*Re: Application of Dino and Michelle DeLaurentiis for Site Plan Approval for the
Construction of a Single-Family Residence and a Tree Removal Permit
To Permit Tree Removal in Connection with the Development of the Residence
Property: 21 Nethermont Ave. North Castle Tax Map Section 122.16, Block 4, Lot 41*

MEMORANDUM

SUBJECT: 21 Nethermont Ave

DATE: June 21, 2022

AVERAGE GRADE EXHIBIT AND CALCULATIONS

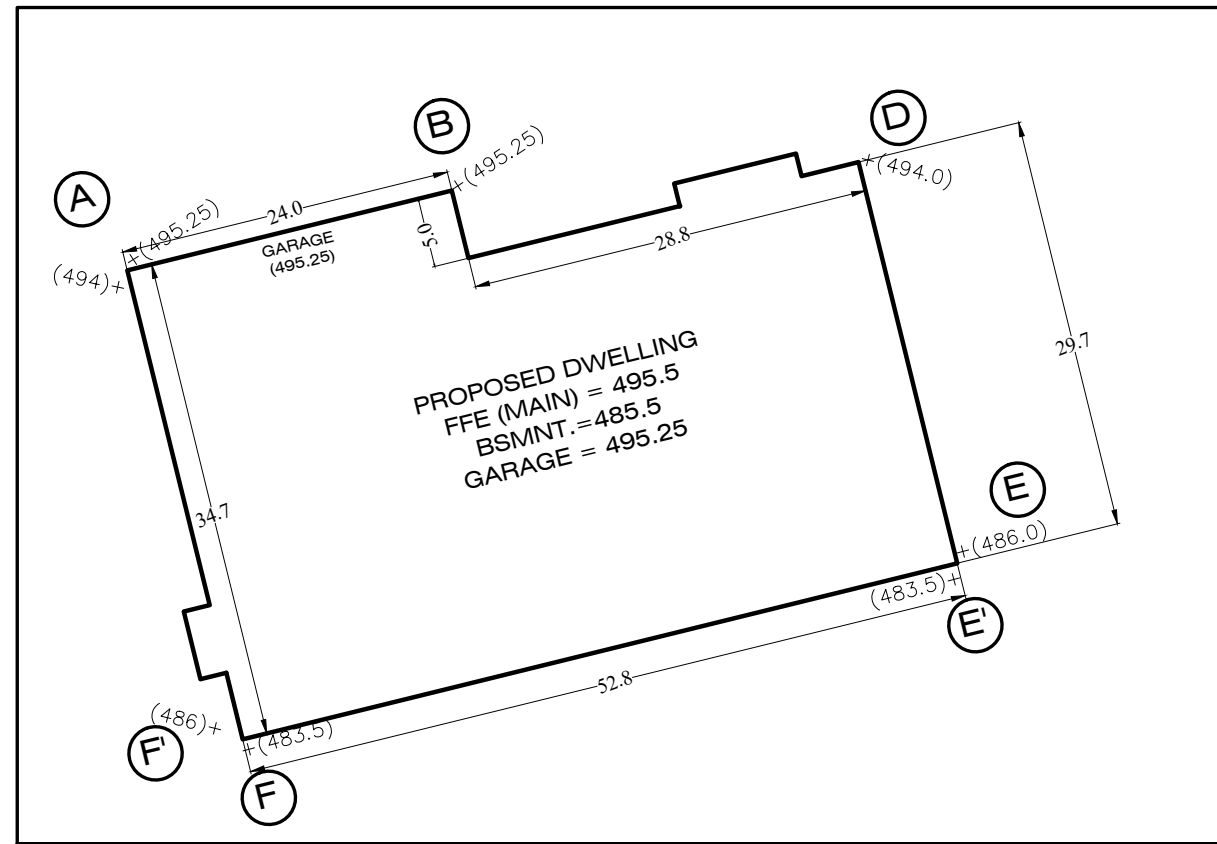
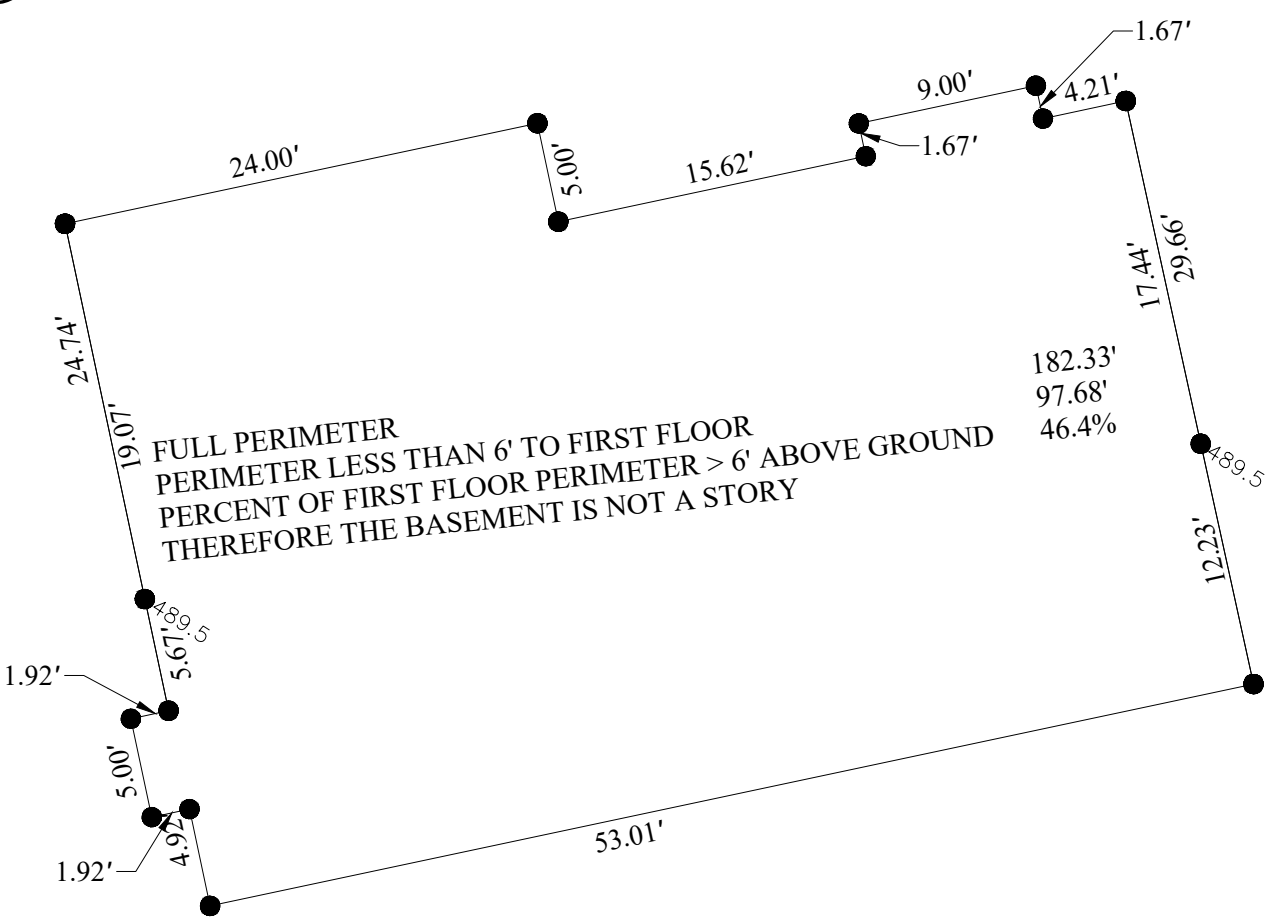
6. The applicant shall demonstrate zoning compliance with respect to building height. As defined by Town Code, the average grade used to determine building height in cases where the finished ground level slopes away from the exterior walls, as this does, the average grade shall be the lowest point within six (6) feet

from the perimeter of the building. The applicant has provided average grade calculations; however, it appears that the elevations were taken immediately adjacent to the building. The calculation and supporting data should be revised accordingly and verified by the Building Inspector.

The above requested revision has not been addressed.

It appears the building height and average grade calculations are correct. The Building Inspector should confirm. Please correct the proposed finished grades at the corners of the garage shown on the average grade exhibit. The applicant should also revise the proposed grade line on the Architect's elevations to comply with the grades used within their calculations.

Building grade calculation and diagram has been revised and are consistent with architect's plan. (Sheet SW-1)

SITE PLAN/ZONING ANALYSIS/GRADING

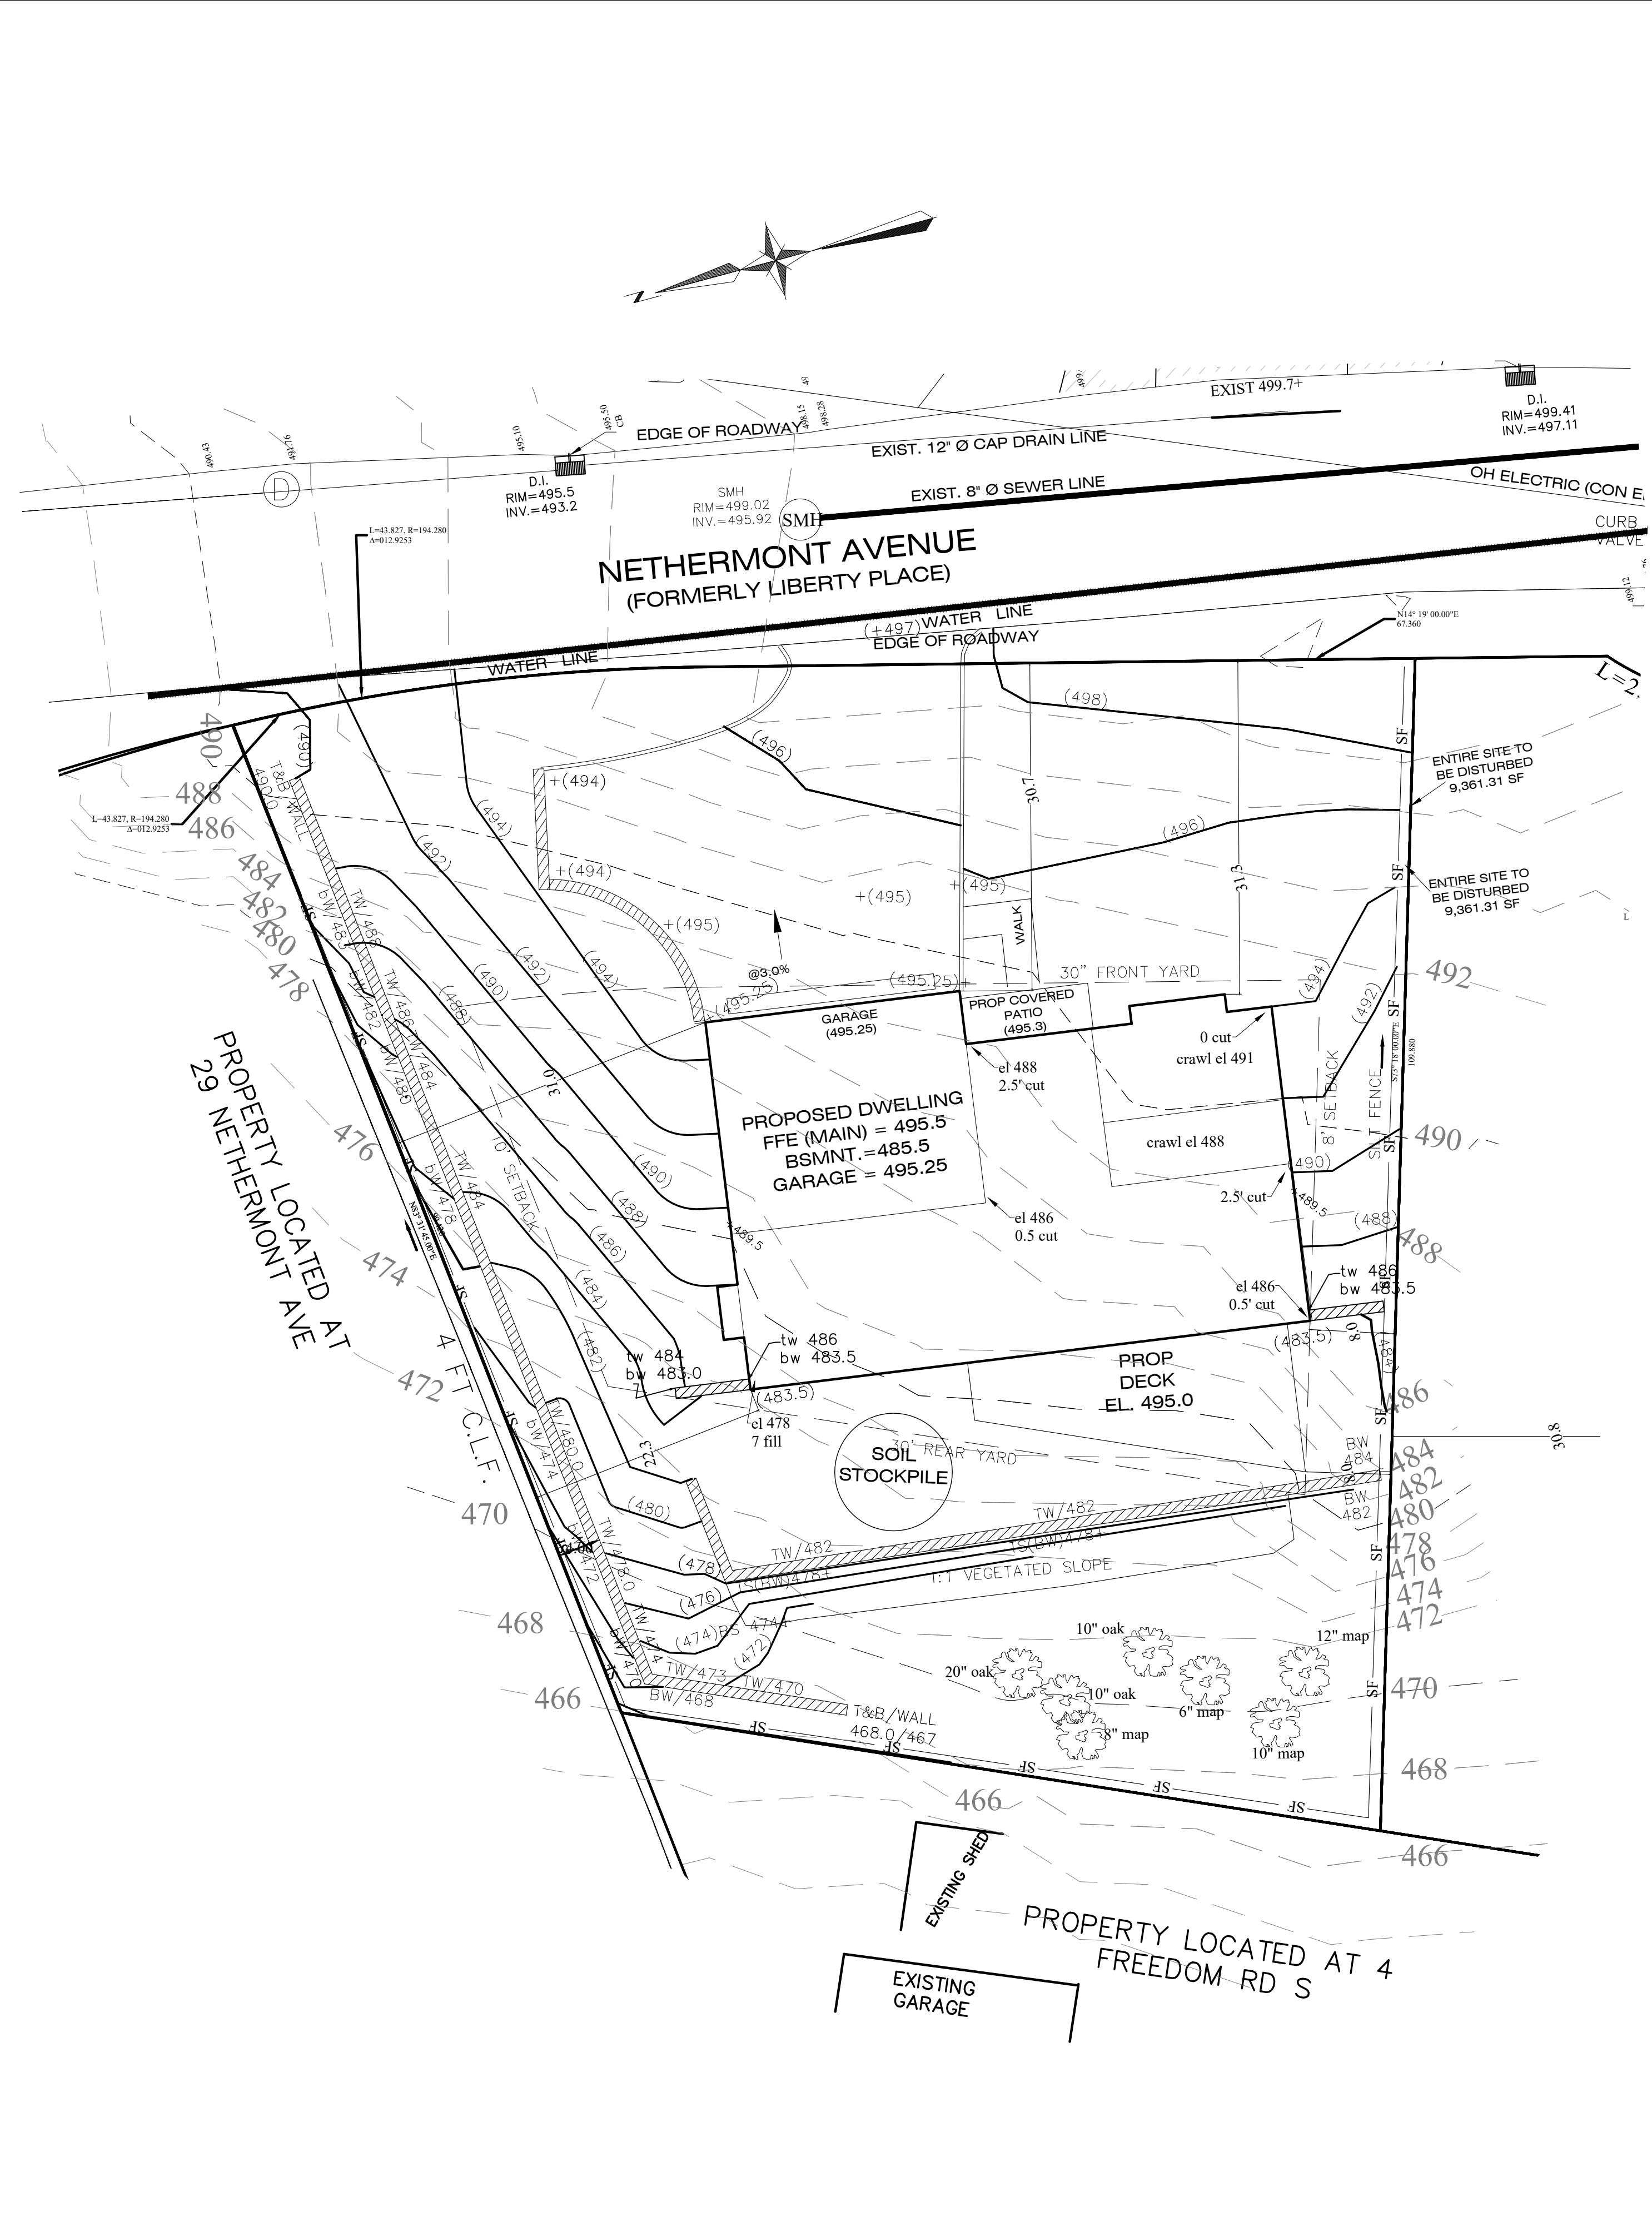
3. As previously noted, the plan proposes tiered six (6) foot high retaining walls in the rear of the property, in close proximity to the property line. The Board should review the retaining wall layout and consider whether they are aesthetically pleasing and compatible with the surrounding residential character. Additional screening or other mitigation may be recommended. The Board may wish to consider reducing the height of the tiered walls or adding a third tier (three — 4-foot walls as opposed to two — 6 foot walls). The applicant should provide cross sections at appropriate locations through the site, front to back and left to right, for the Board's understanding of how the proposed grading and retaining walls will relate to adjacent properties.

While minor modifications to the retaining wall layout have been proposed, it is our opinion that additional modifications can be made to further reduce the retaining walls along the property lines as well as to improve the proposed grading adjacent to the residence. As currently proposed, the finished grade immediately falls from the foundation providing no level side yard and poor access to the proposed stairs at the northwest corner. The applicant may wish to consider shifting the wall along the side yard toward the home or adding a short second tier to flatten the proposed grades around the house. It also seems that the wall at the rear property line could be shifted further into the site to minimize visual impact to the adjoining property. The requested cross sections have not yet been provided.

4. As previously requested, for clarity and ease of review, the applicant shall provide a separate Site Plan and Grading and Utility Plan in addition to the Existing Conditions Plan. Due to the drawing scale and abundance of data included on a single sheet, it is difficult to decipher the various improvements from one another. The applicant should prepare a site plan that includes all proposed improvements, including, but not limited to, proposed residence, walkways, patios, driveway including dimensions, a zoning compliance table, the minimum building envelope illustrating building setbacks and dimensions, retaining walls and existing neighboring buildings and driveways. Proposed grading, utilities, erosion controls, etc., should be illustrated on separate plan sheets.

A Bulk Zoning Table has been provided; however, the references to Net Lot Area should be removed as they do not apply to single lots. The minimum required building envelope should be illustrated on the plan. The applicant has indicated that the information requested above will be submitted at a later date.

16. The plans shall include a note indicating the source of the survey and topographic data, including the referenced datum, utilized for the development of the plan.

At the May 23rd meeting of your Board on this Application the applicant was advised to consult with Town Engineer John Kellard about alternatives to the wall design proposed on the Site Plan/Zoning Analysis/Grading Plan (SW-1), prepared by Gabriel E. Senor PC, dated October 3, 2021, last revised May 5, 2022. The applicant has consulted with Mr. Kellard about that aspect of the plan and based on that consultation, we have replaced the originally proposed rip-rap slope with a 1:1 vegetated slope to preserve 6 Town Regulated existing trees and one tree with a DBH of 6 inches in the rear of the property.

See Site Plan/Zoning Analysis/Grading (SW-1), prepared by Gabriel E. Senor PC, dated October 3, 2021 last revised June 23, 2022 submitted herewith.

Plans have been separated as follows: Site Plan/Zoning Analysis/Grading, Utility Plan and Cross Sections for clarity. Building envelope is shown on plan SW-1 and Net Lot Area has been removed.

The requested note has been added to Sheet SW-1.
